Canon SERVICE REPORT

NO. R-5003E-1/2

MODEL: Canola SX-100 & SX-300

SUBJECT: Modification to stabilize oscillator circuit

P. 10 in "REPAIR GUIDE 1" of Canola SX-100.

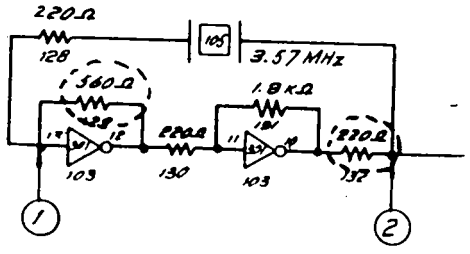
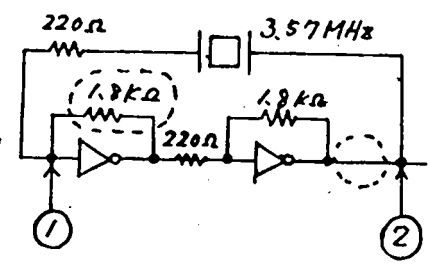
Outline : It was found that the machines didn't work when frequency of crystal oscillator was changed from pre-set one. (3.57 MHz). Therefore, 2 resistors in oscillator circuit are changed to avoid above mentioned trouble.

Modification:
Changed resistors in oscillator circuit are as follows.

Original.

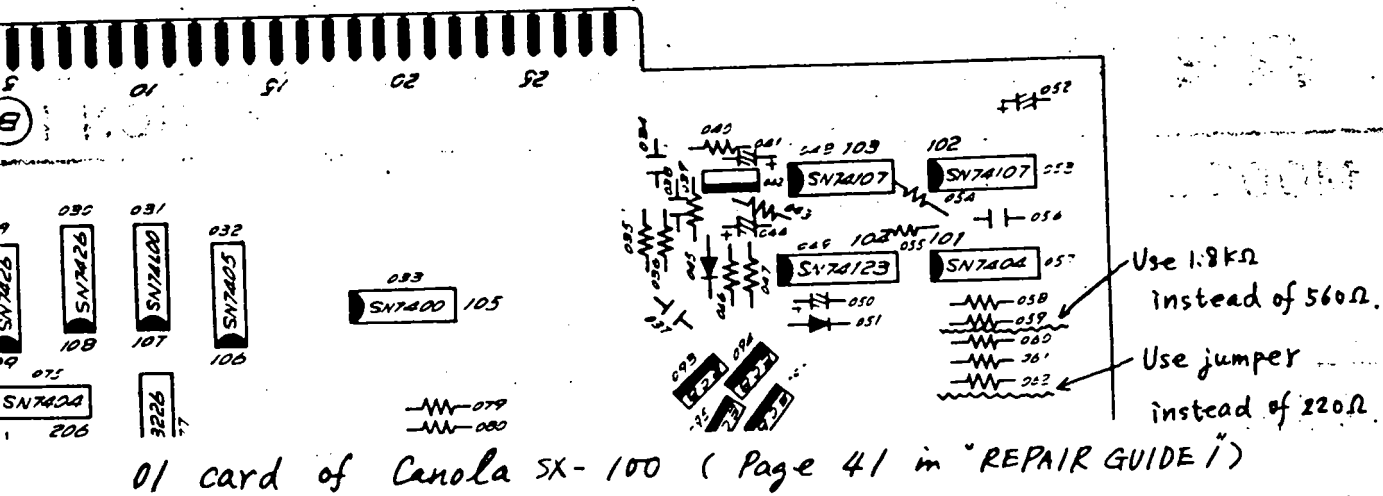
Modified

01 card of Canola SX-100 (Page 41 in "REPAIR GUIDE")

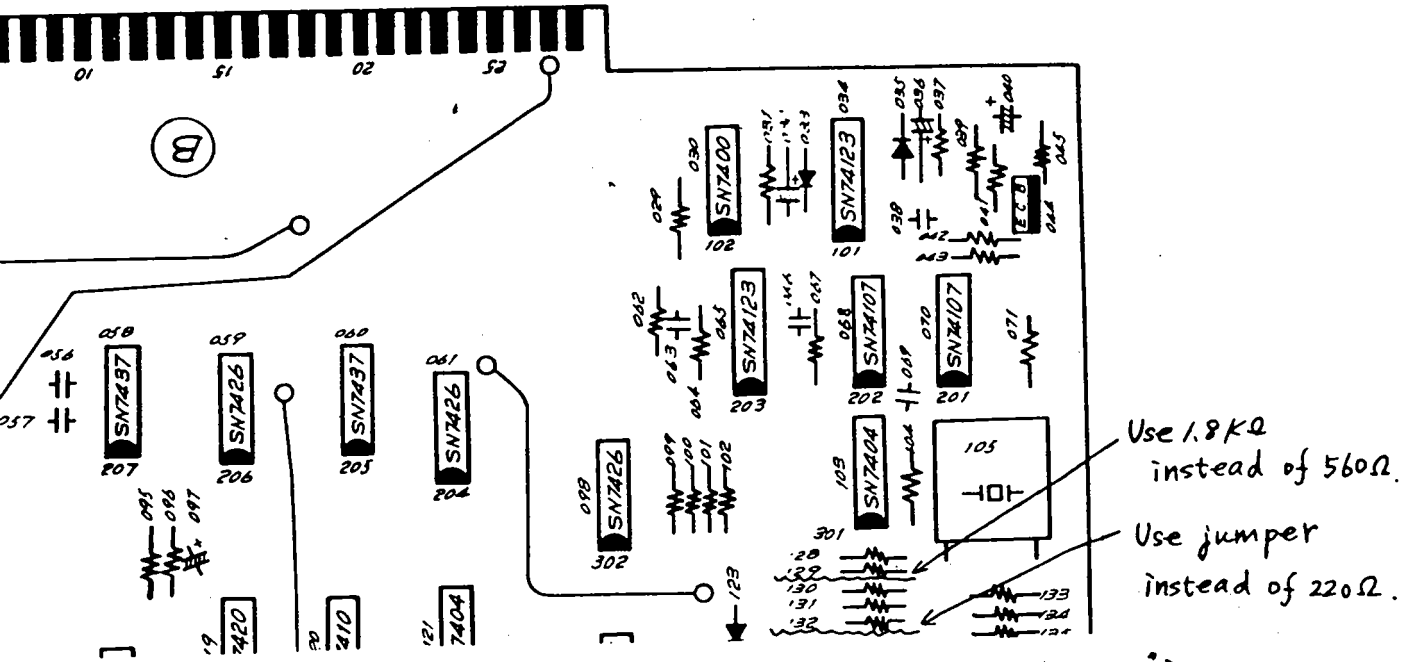
Positions of 2 resistors on 01 card are shown below.

- Added "Protection Circuit"

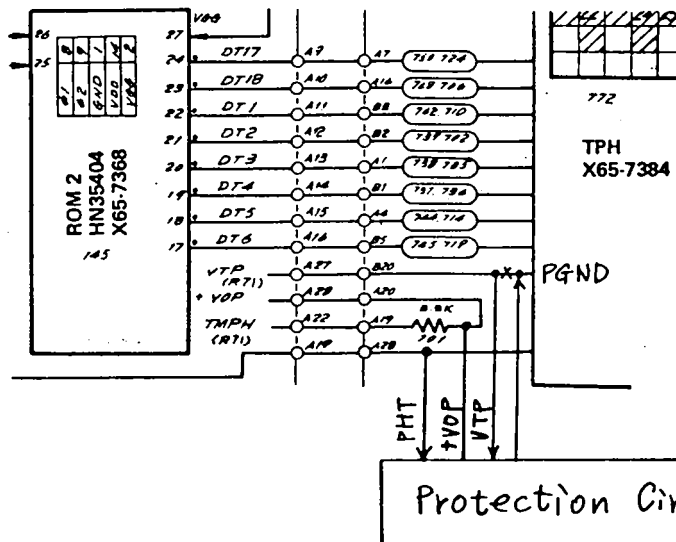
Outline : It was found that a thermal print head might be broken when short circuit was made by accidental operation of a probe while repairing defective machines. Therefore, a "Sub-printed Board" for "Protection Circuit" is being added in a "Printer Unit" as shown below.

- Position of "Protection Circuit" in wiring diagram

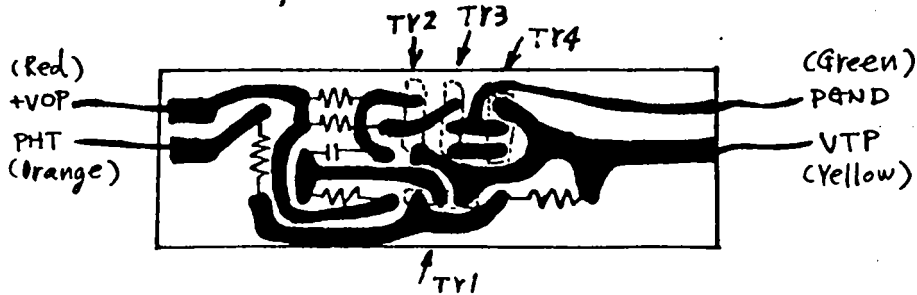
"REPAIR GUIDE" on P. 38 for SX-100 & SX-300.

- The attaching method of a "Sub-printed Board" is as follows.

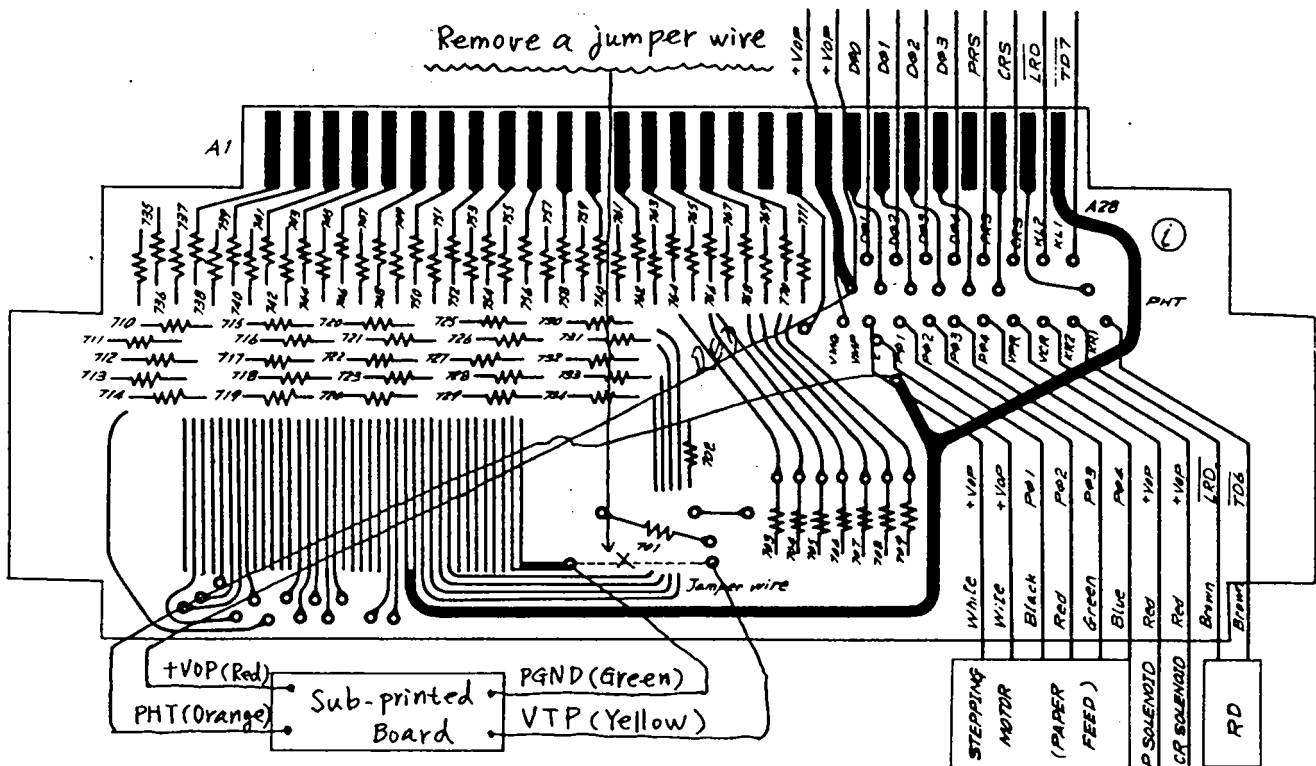
N.B.) Attach a "Sub-printed Board" by adding a "metal fixture" on a "Printer Unit".
